ADDENDUM #2

Reference: Greendale Maintenance Station Replacement
Utah Department of Transportation – Daggett County, Utah
DFCM Project No. 07029900

Subject: **Addendum No. 2**

2.4.1 The complete **drawing set has been revised and is re-issued with this Addendum.** Owner requested the deletion of the mezzanine and mezzanine access. Walls around office area extend 18'-0" A.F.F. Building footprint has been revised to incorporate larger truck bays. All drawings for all disciplines have been revised showing new building footprint & layout.

AE203

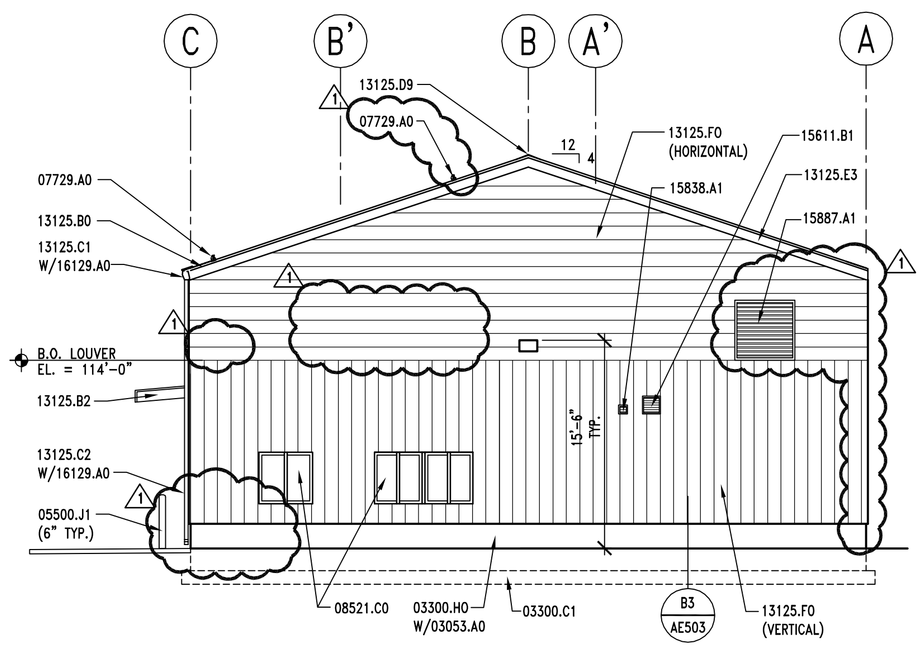
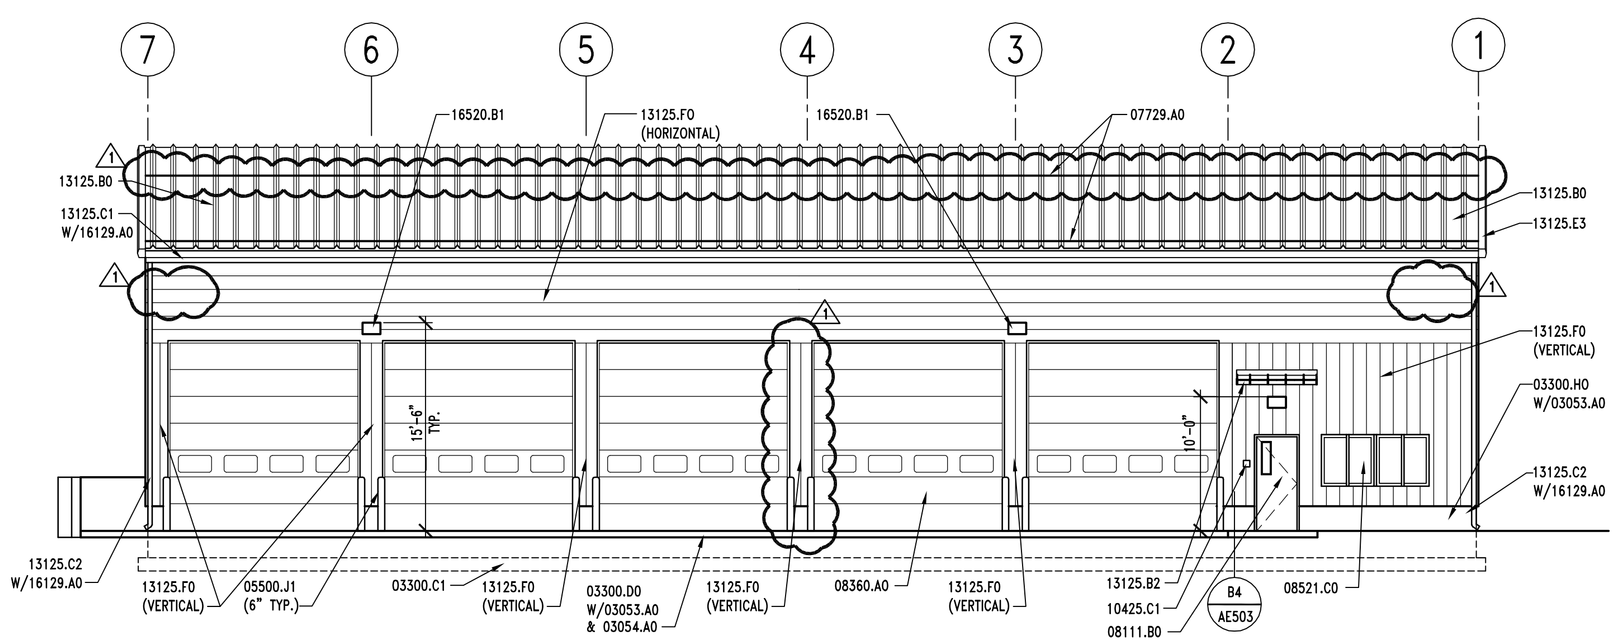
a. Added second row of Snowguard system.
b. Revised exterior light fixture layout.
c. Relocated Emergency disconnect.
d. Relocated upper Exhaust fan/louver.
e. Deleted rain gutter, downspouts & snow guard at back of building only.
f. Deleted center downspout at East elevation.
g. Deleted Upper mezzanine window.

AE204

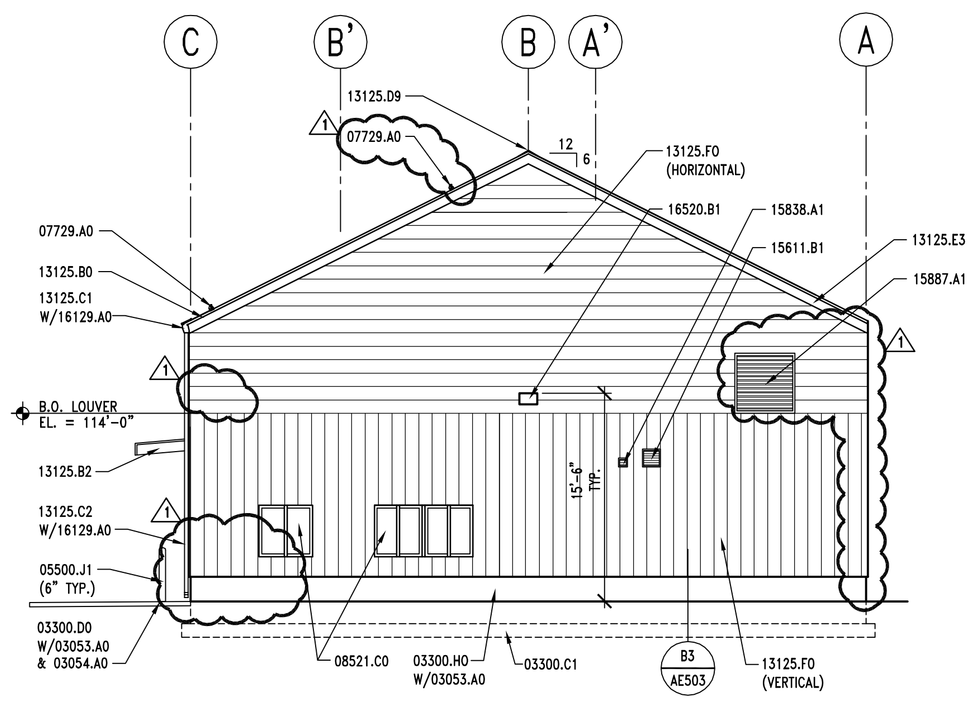
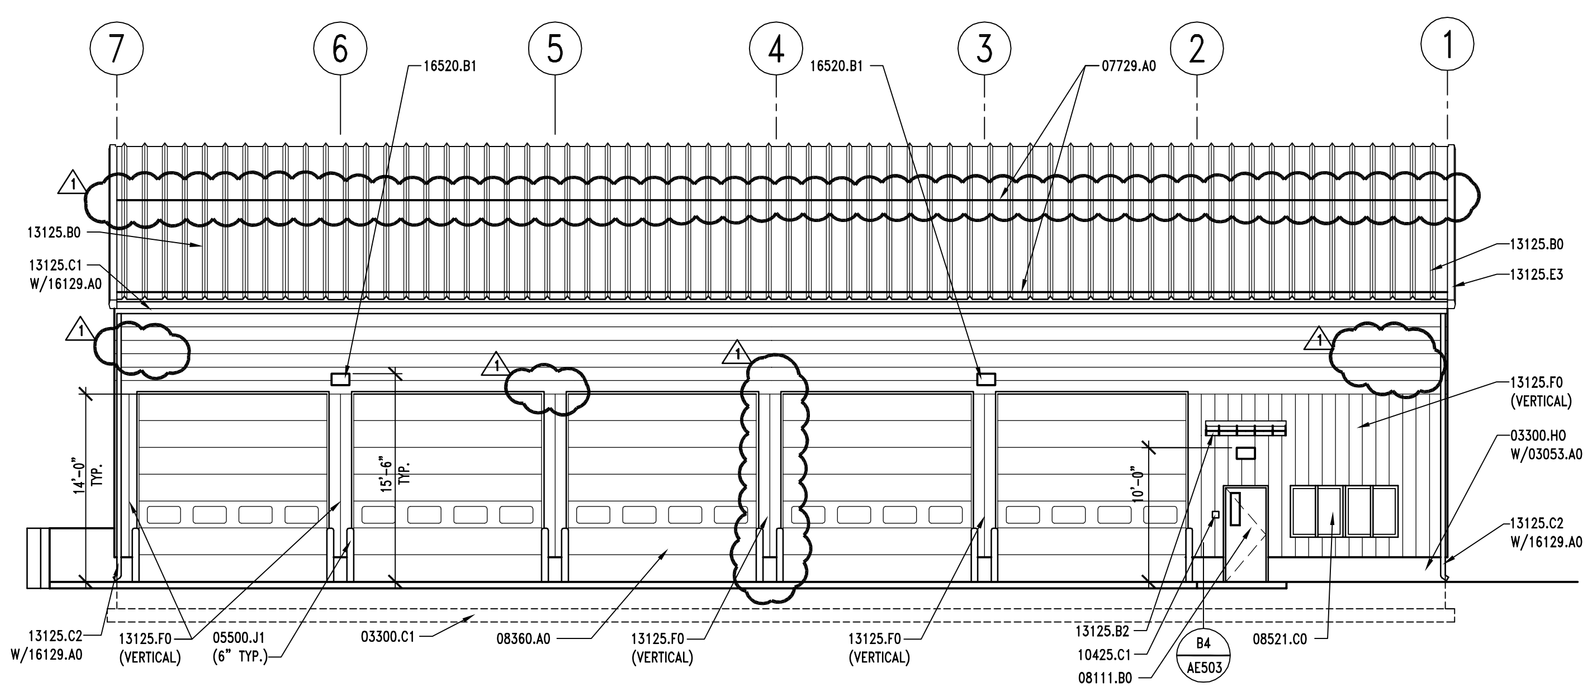
a. Added second row of Snowguard system.
b. Revised exterior light fixture layout.
c. Relocated Emergency disconnect.
d. Relocated upper Exhaust fan/louver.
e. Deleted rain gutter, downspouts & snow guard at back of building only.
f. Deleted center downspout at East elevation.
g. Deleted Upper mezzanine window.

AE301

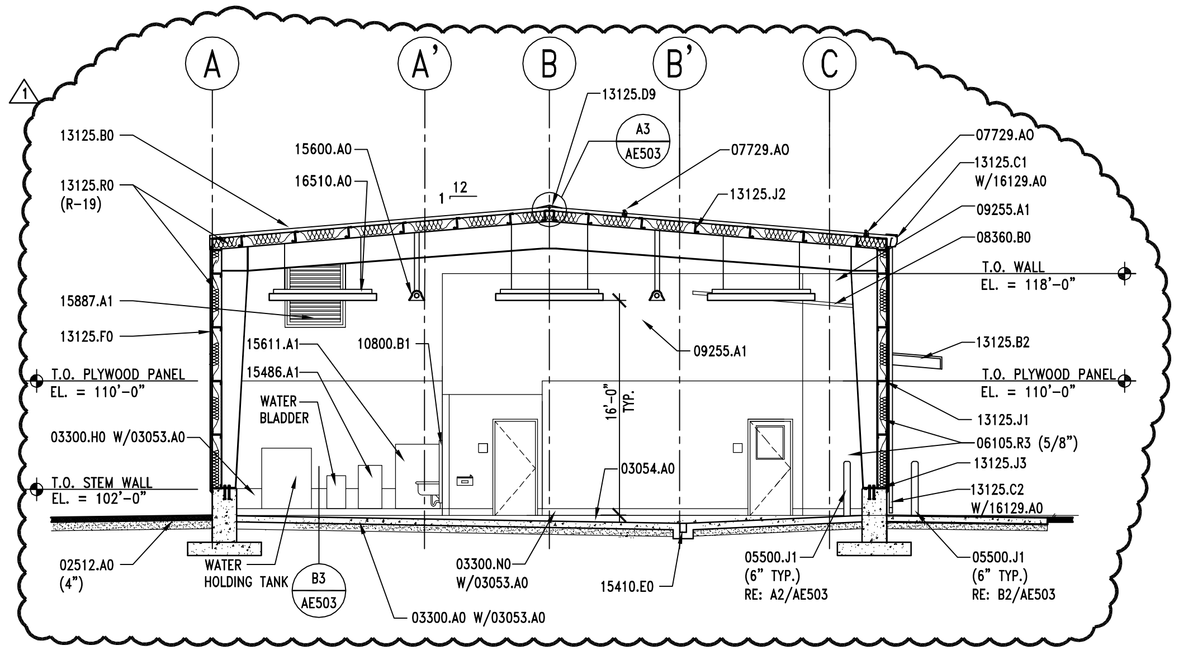
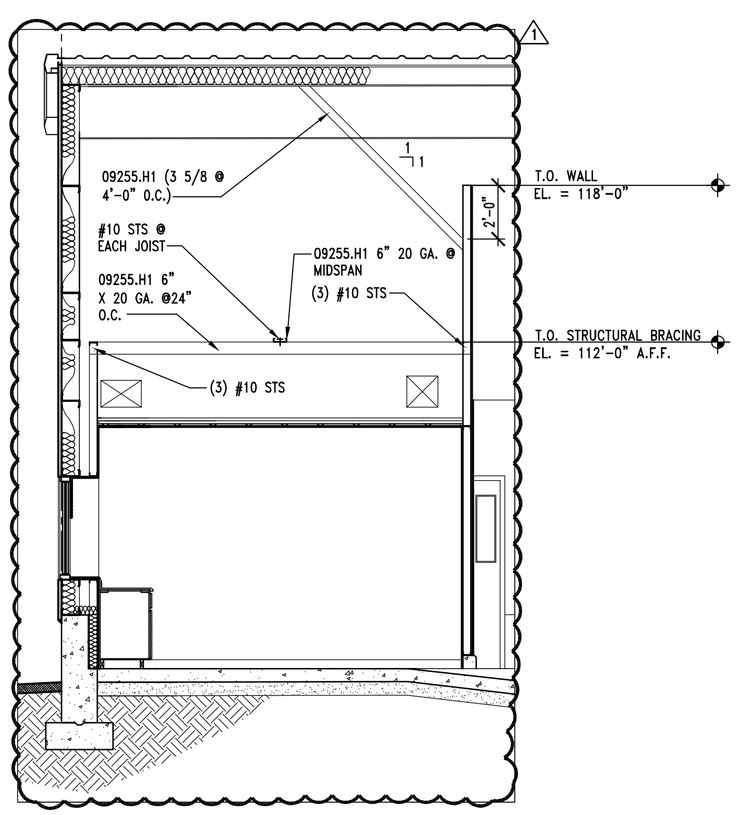
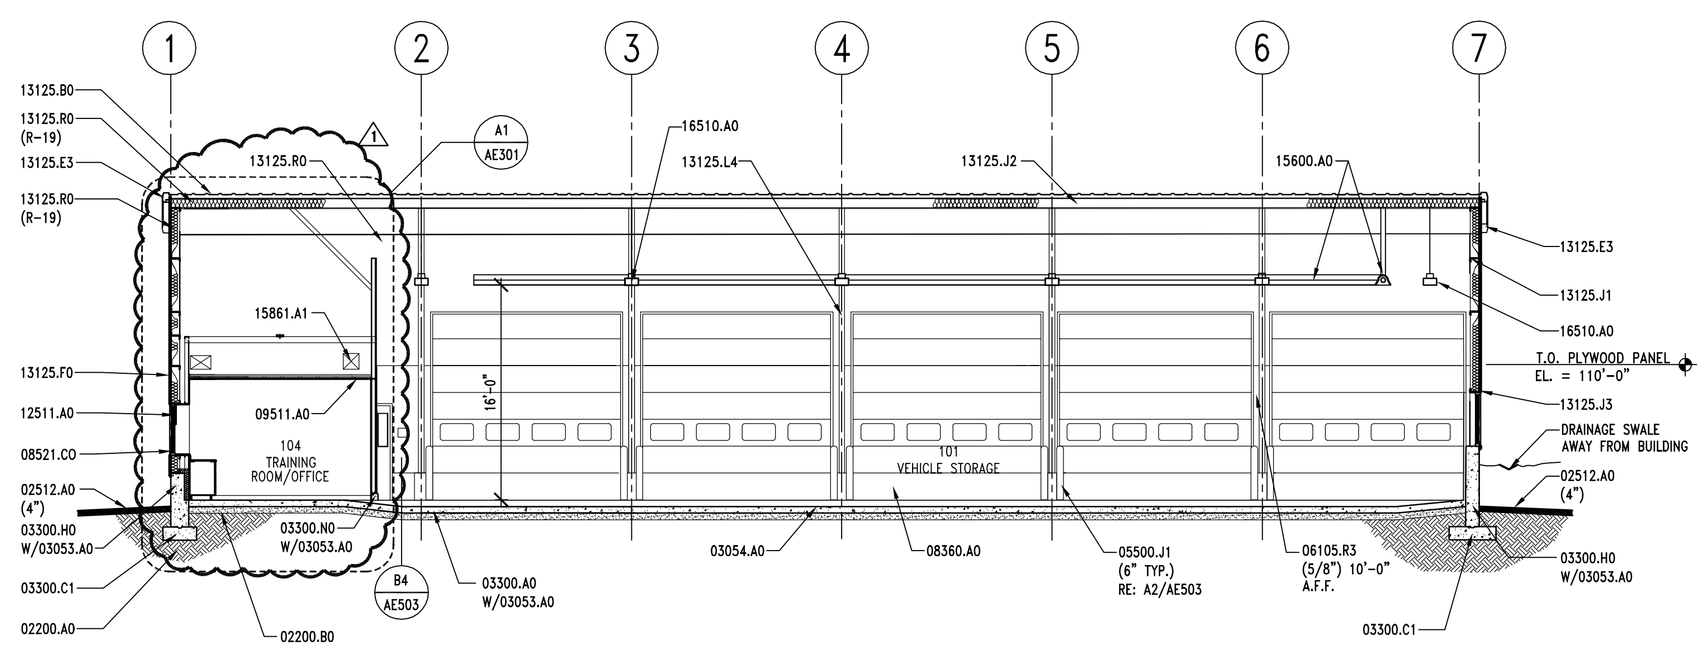
a. Added enlarged Structural bracing section.
b. Revised top of wall condition.
c. Revised storage area layout.
d. Deleted mezzanine & stairs

A1 WALL TYPES

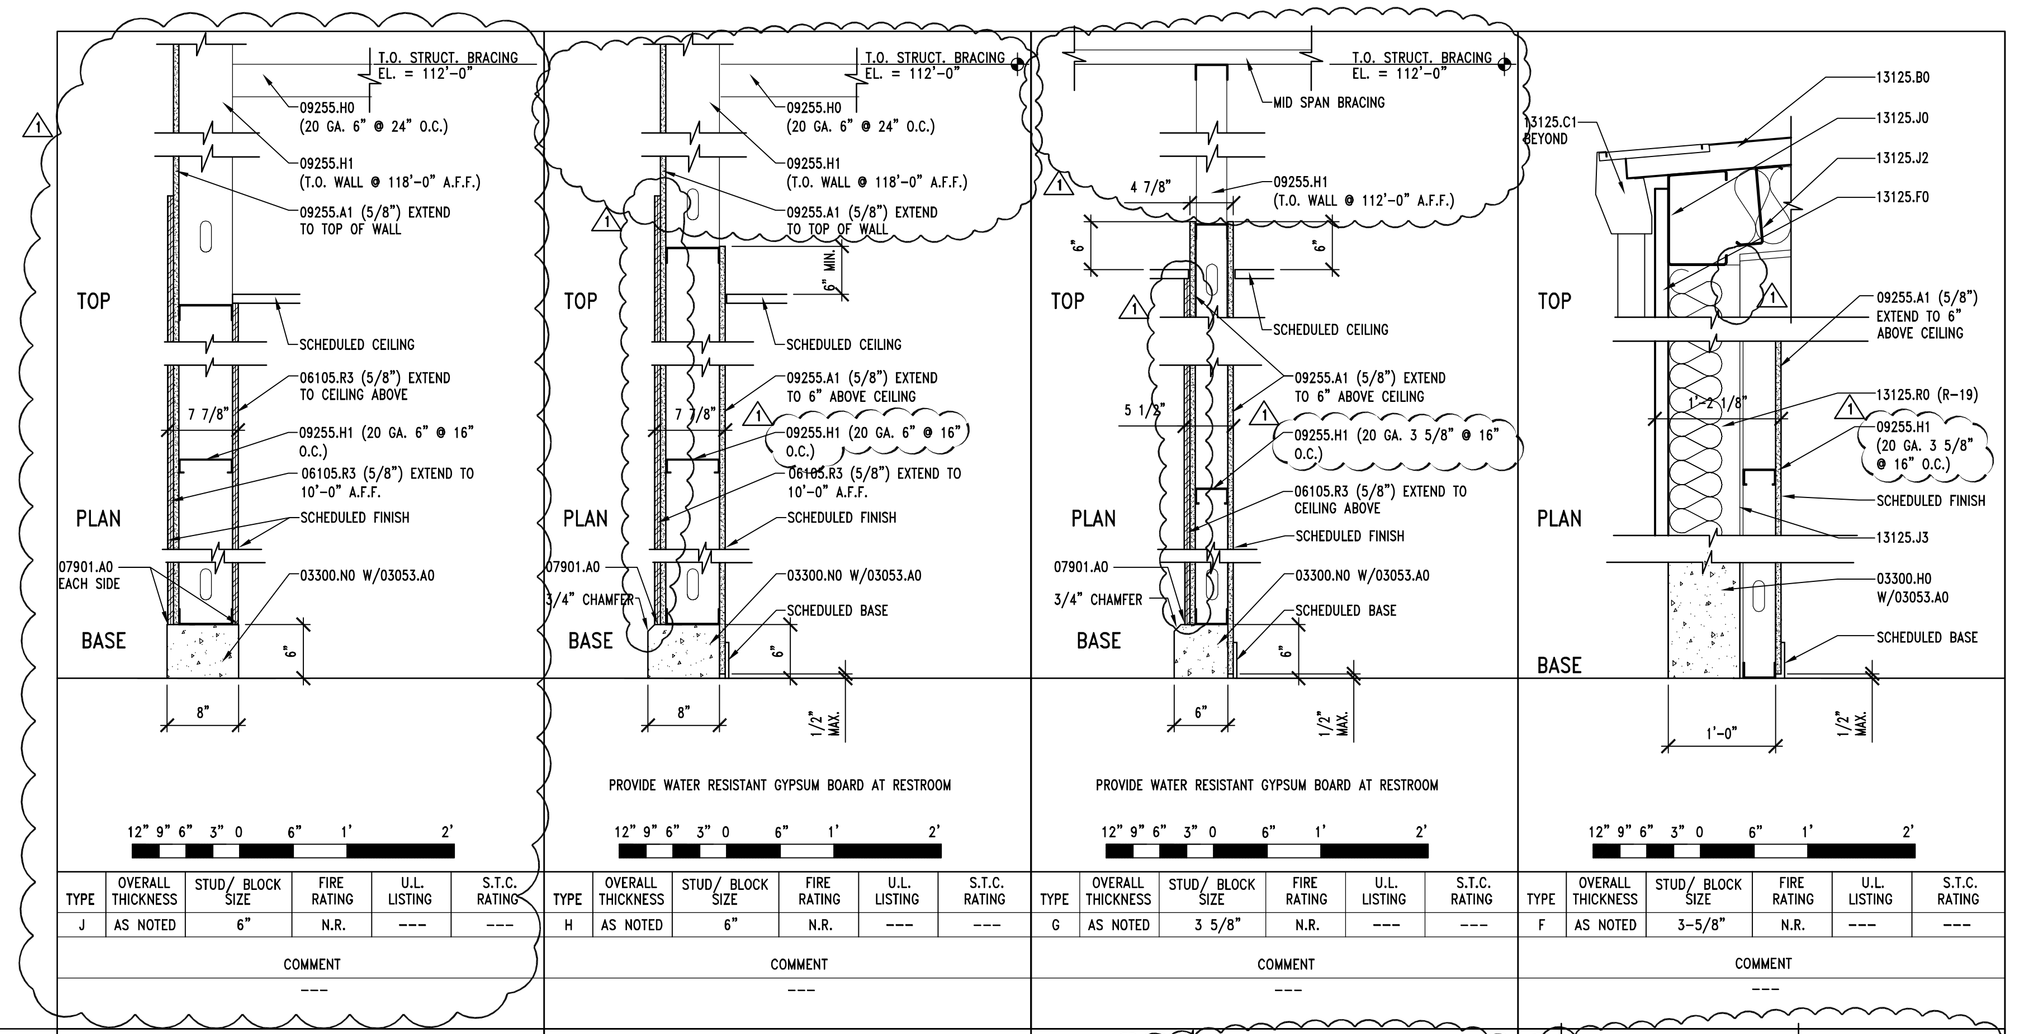
2.1 Added Wall type "J".
2.2 Revised wall types A, B, D, F, G & H.

C4 | CEILING DETAIL

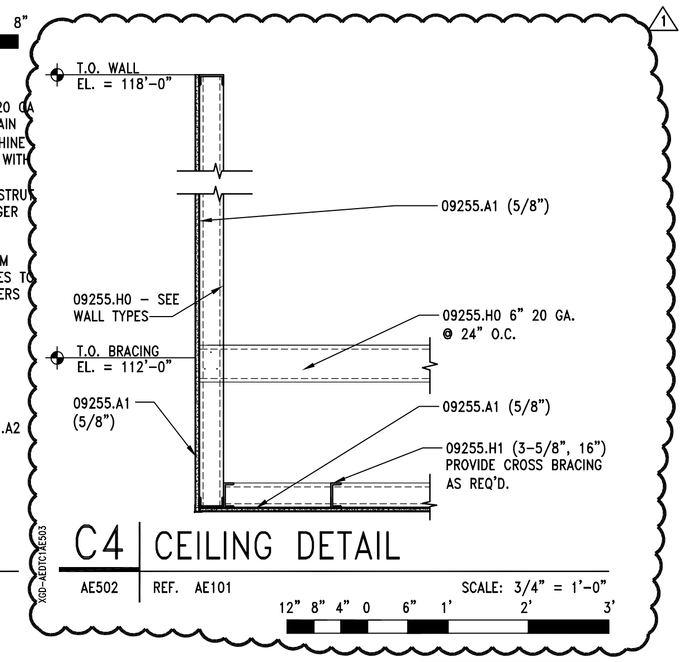
a. Revised Interior Elevation A3/AE502.
b. Revised Ceiling Detail C4/AE502.
c. Deleted details B2 & A2/AE502.

A4 | GUTTER DETAIL

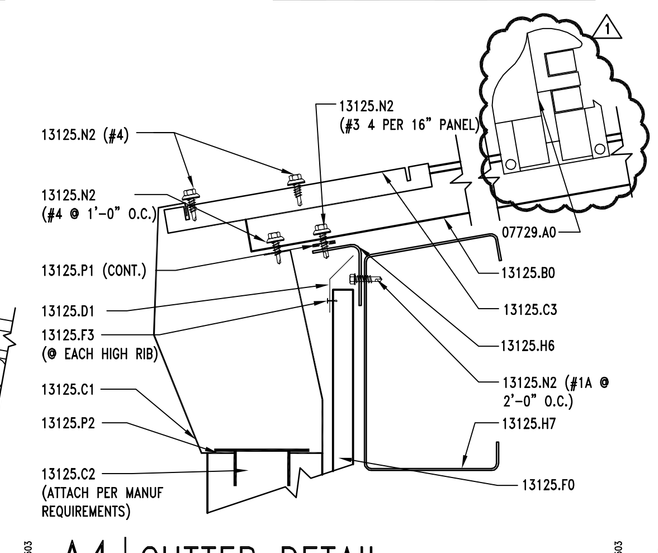
a. Added Snowguard fence system in detail A4/AE503.
b. Deleted Details C2 & D3/AE503

C2 | SECTIONAL DOOR JAMB DTL.

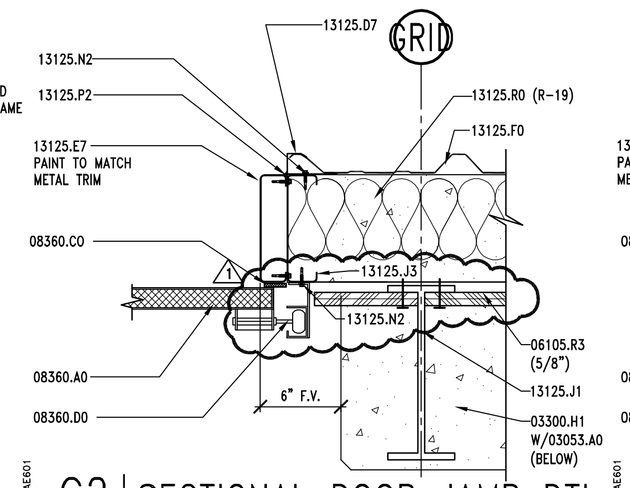
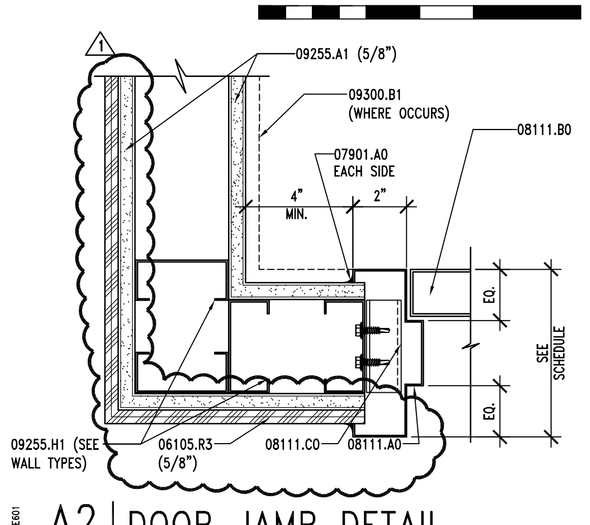
a. Revised door schedule to show door frame widths.
b. Revised details A1, A2, B2 & D4/AE601 to show plywood panel.
c. Revised plywood attachment at column conditions – Detail C2/AE601.
